### Proposals on mandatory fitment of safety valves to tanks carrying flammable liquefied gases – Document ECE/TRANS/WP.15/AC.1/2021/36

#### Transmitted by the European Industrial Gases Association (EIGA)

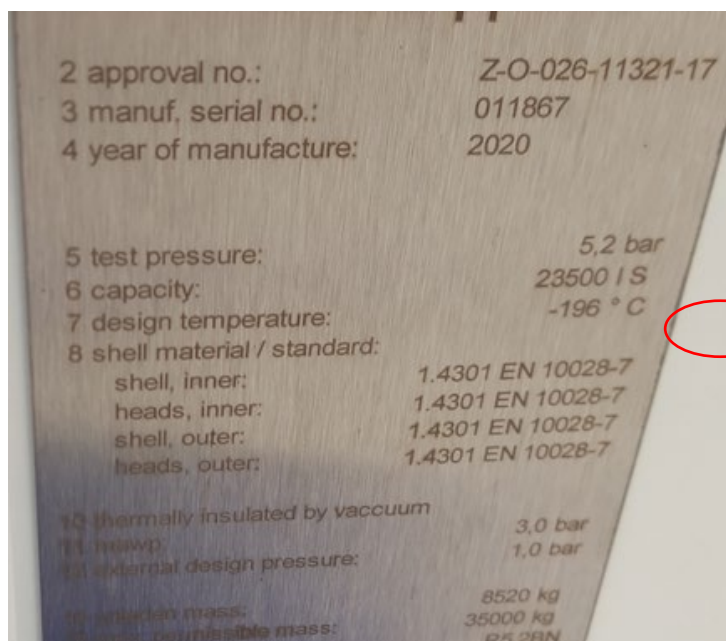
1. EIGA supports Proposals 1 and 3 in document ECE/TRANS/WP.15/AC.1/2021/36.
2. EIGA is not in agreement with Proposal 2. In the current regulations, the marking of the letter “S” is used to indicate that shells or compartments are divided by surge plates, see 6.7.2.20.1 and 6.8.2.5.1. An example of such a mark is given below.

3. EIGA believes that it could cause confusion if the same mark is used to indicate a different meaning, even if it is marked in a different place.
4. As all tanks for refrigerated liquefied gases (6.8.3.2.11) and many tanks for liquefied gases (current 6.8.3.2.9) already have safety valves in line with the regulations, EIGA believes that it is easier and clearer if tanks which do not have safety valves are identified.
5. This would highlight the risk of BLEVEs occurring on these tanks. EIGA proposes marking these tanks, for example with an “H”, indicating that they are to be considered hermetically closed.
6. Orange coloured plates are used to identify dangerous goods and the associated hazards. These marks do not correspond with the equipment used to transport the dangerous goods. This may not be the best place to have marks concerning transport equipment design.
